Opal St Clair

Response to letter 19th November 2021

17th June 2022

Existing streetscape - existing trees retained

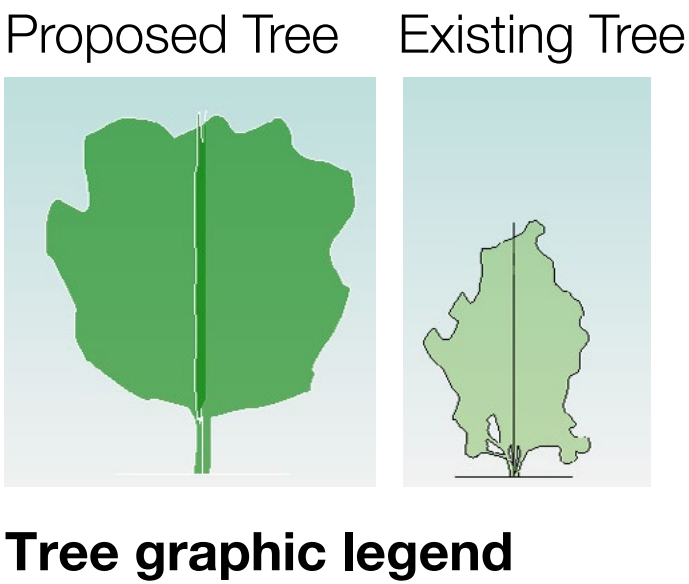
Concern is raised regarding the proposal from a streetscape and a residential / neighbourhood character perspective, including given the treatment of facades, and the placement and alignment of utility infrastructure within the front setback area. It is noted that Council's Urban Design Review Panel have reviewed the proposal and have raised issue in this regard, in relation to the dominance of the street setback by hardscape, surface parking and services, and the colour scheme and reliance on painted render.

The services / utilities along the front boundary were located in the position shown on the site plan for the following reasons:

The services are located at the front of the property as the authority services in the street verge and footpaths are directly in front the locations as the follow the road and turn 90 degrees under the road surface and follow the road. If moved to the other end of the site, all authority services mains, water and gas, would need to be extended along the front of the site.

The booster is required to be located at the site boundary and within 8m of a hardstand area as required by AS2419.1-2005,cl 73 (d) as below

Site plan

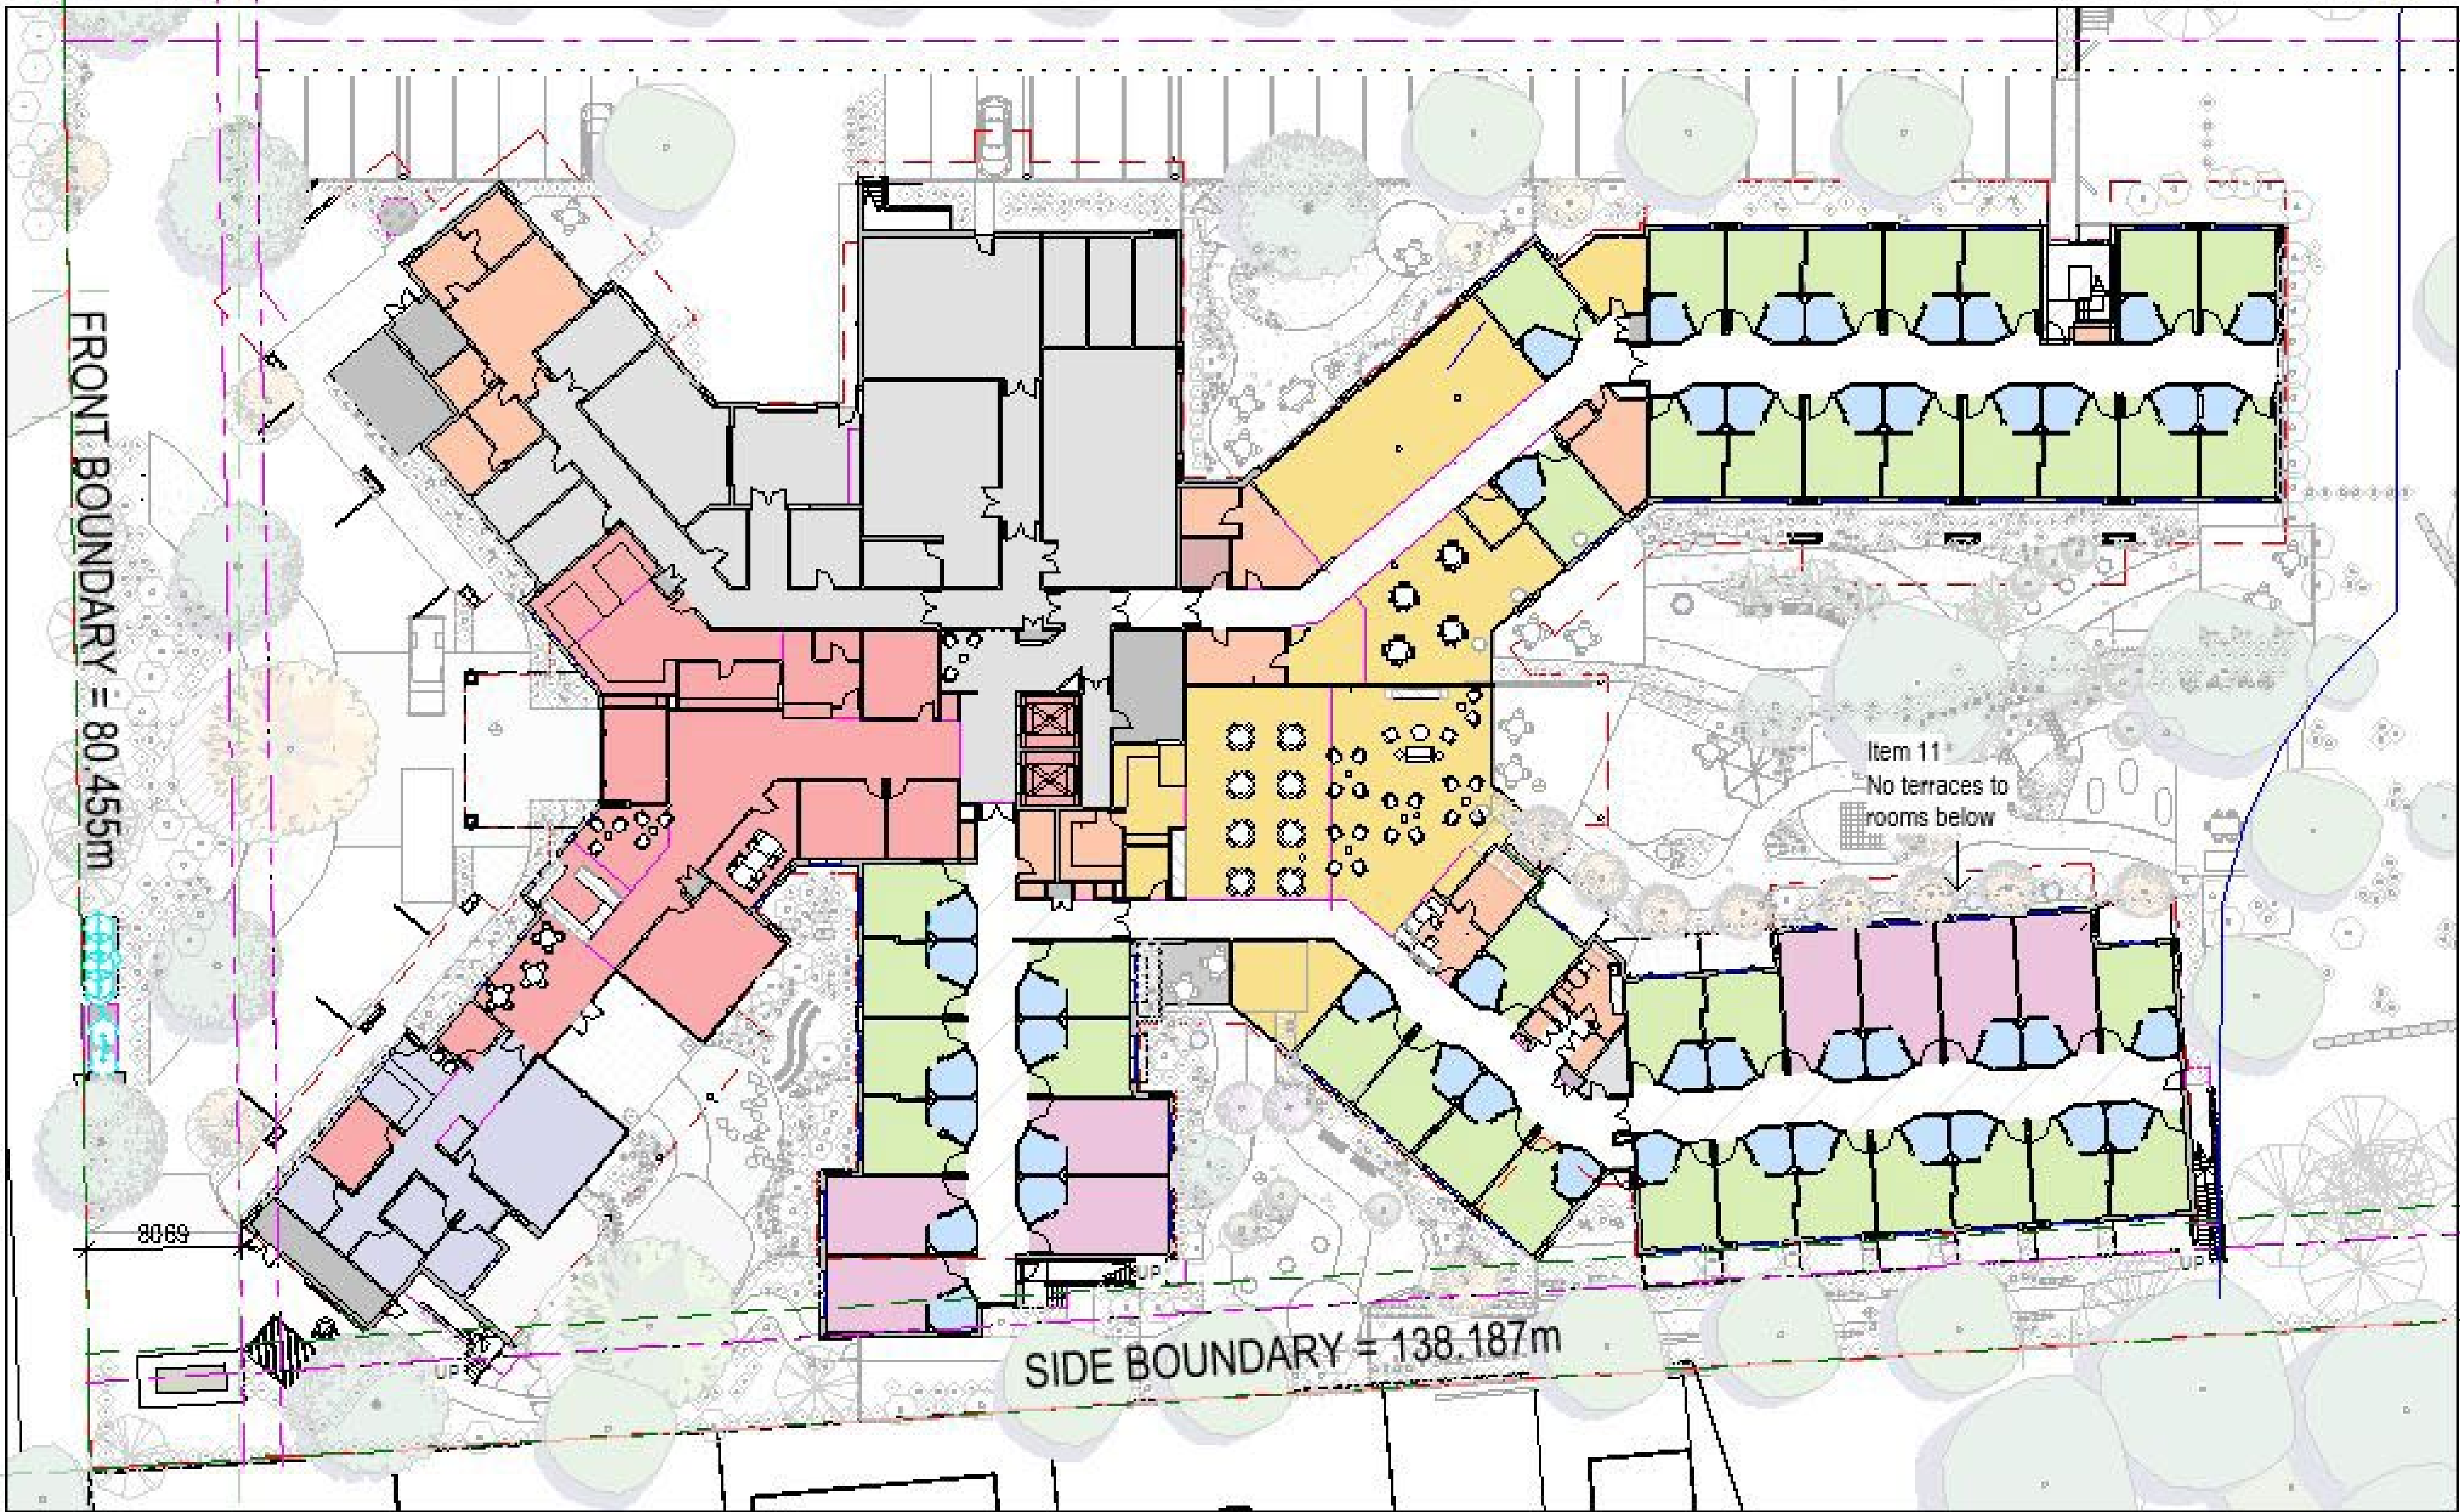
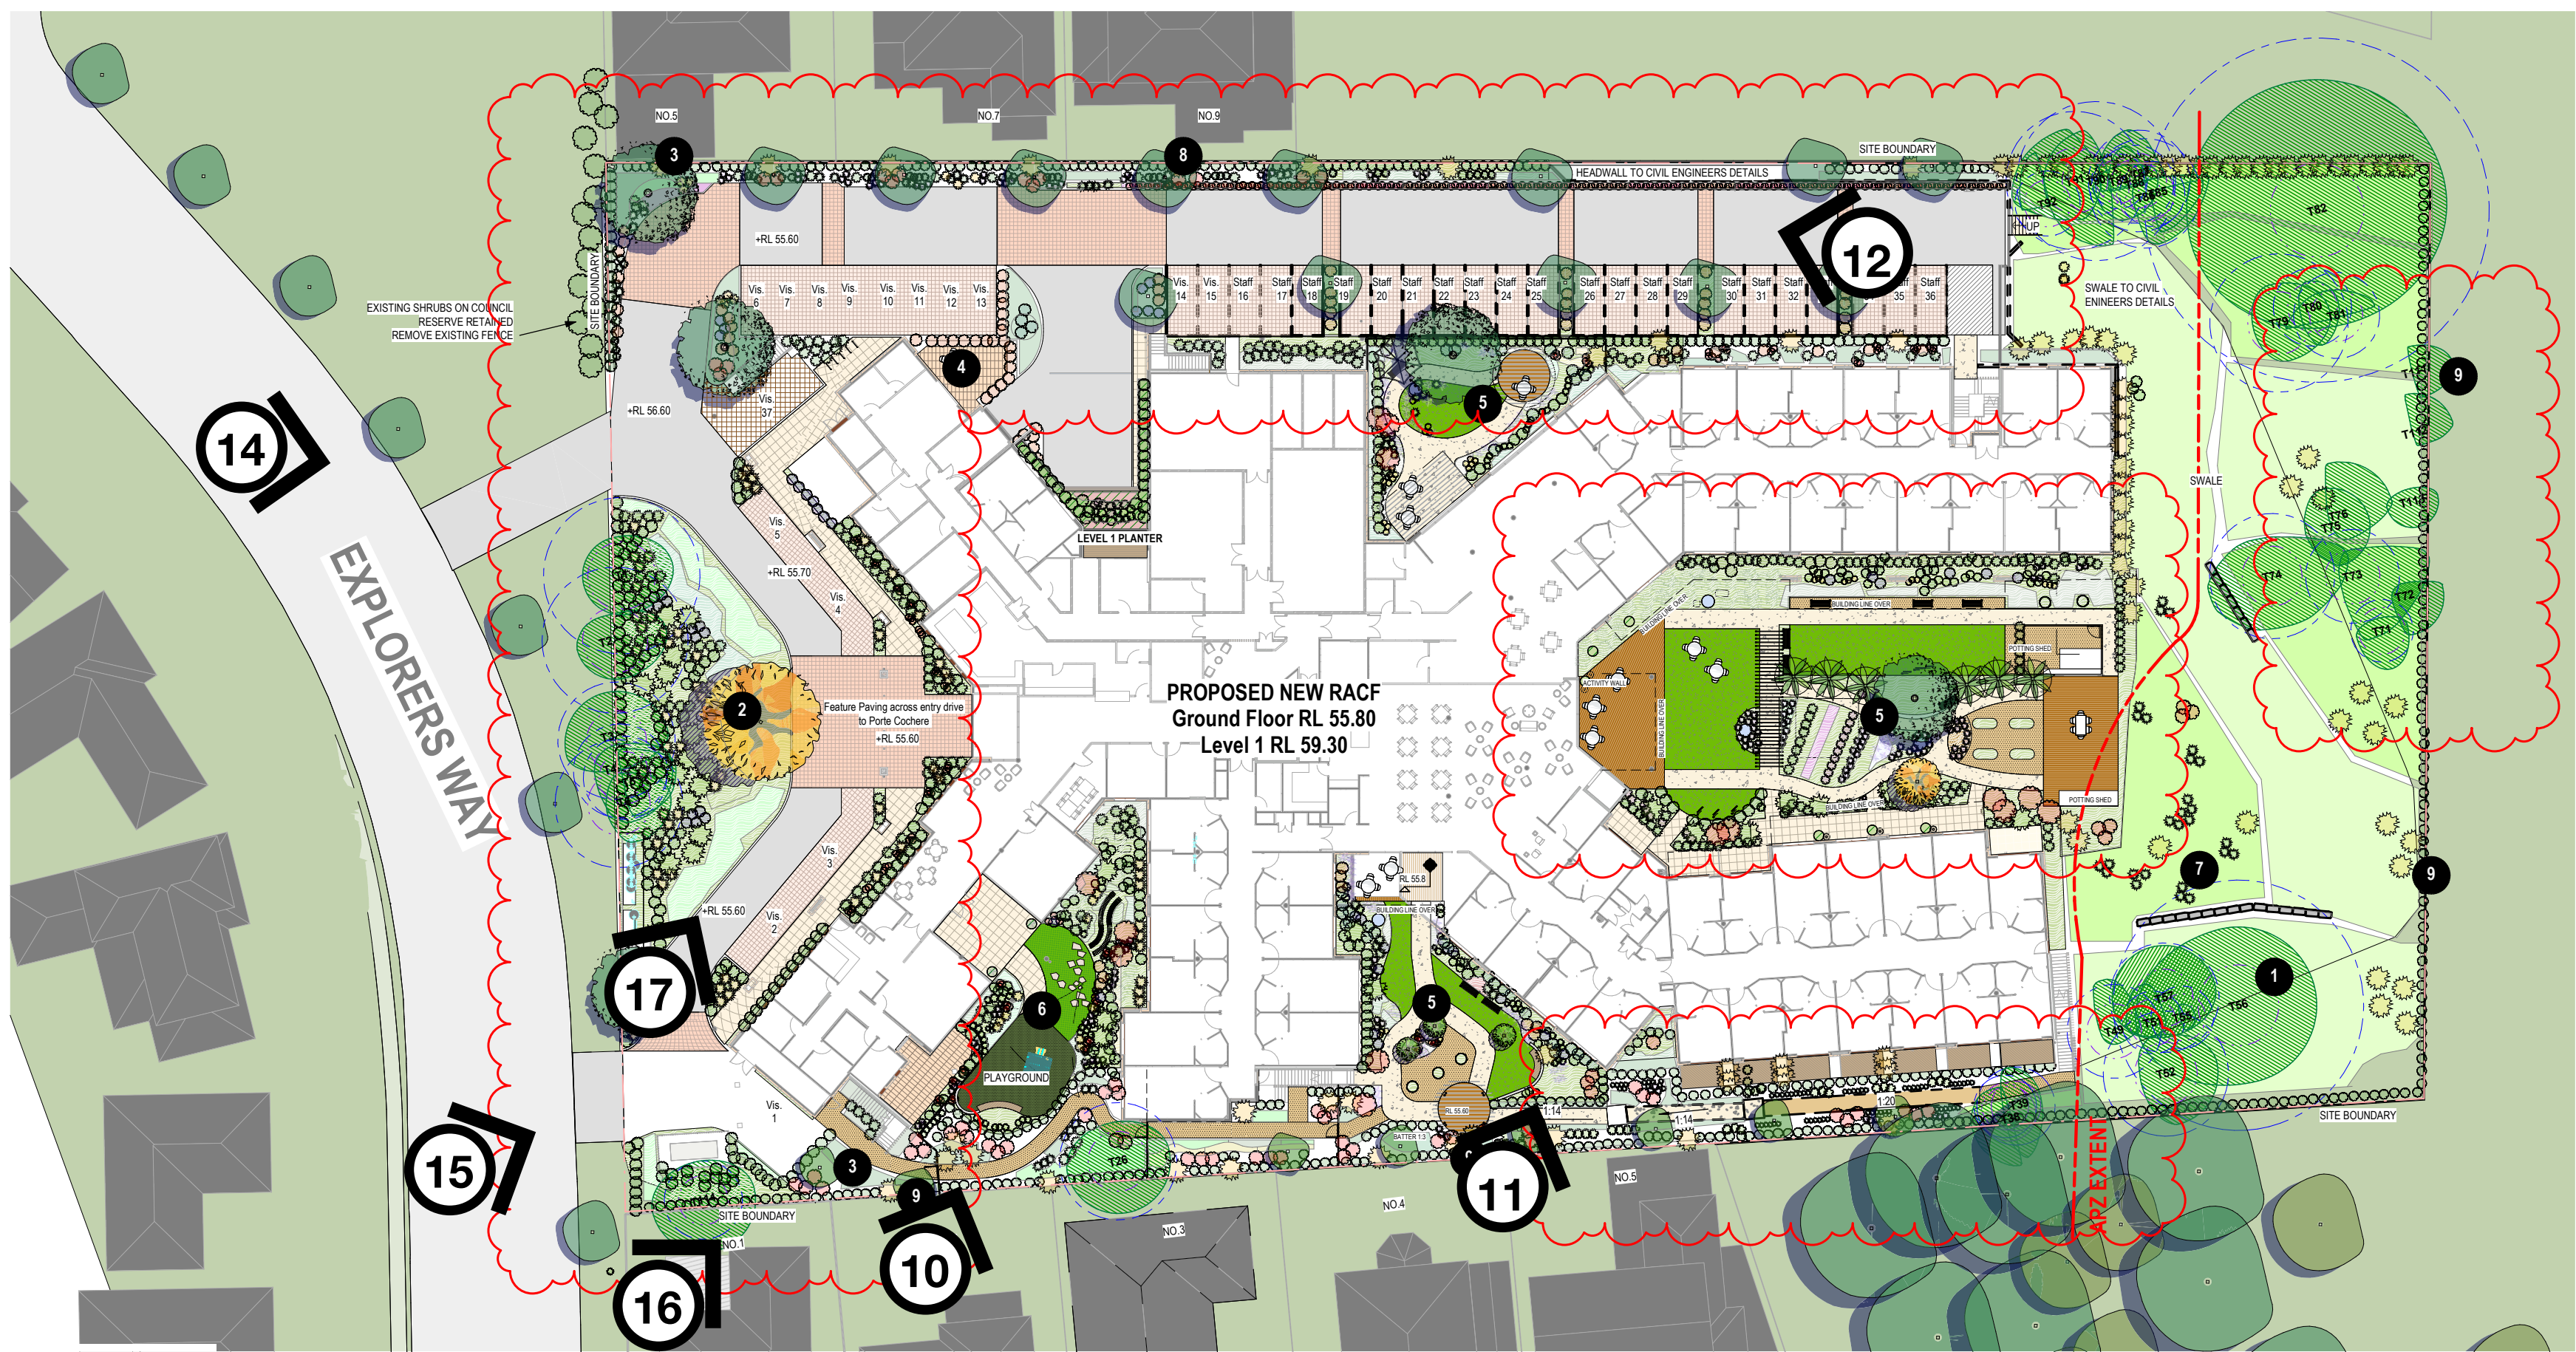
The submitted Site Plan does not clearly depict the extent of the First Floor elements which overhang beyond the Ground Floor.

Refer plan below showing level 1 overhang dashed in red
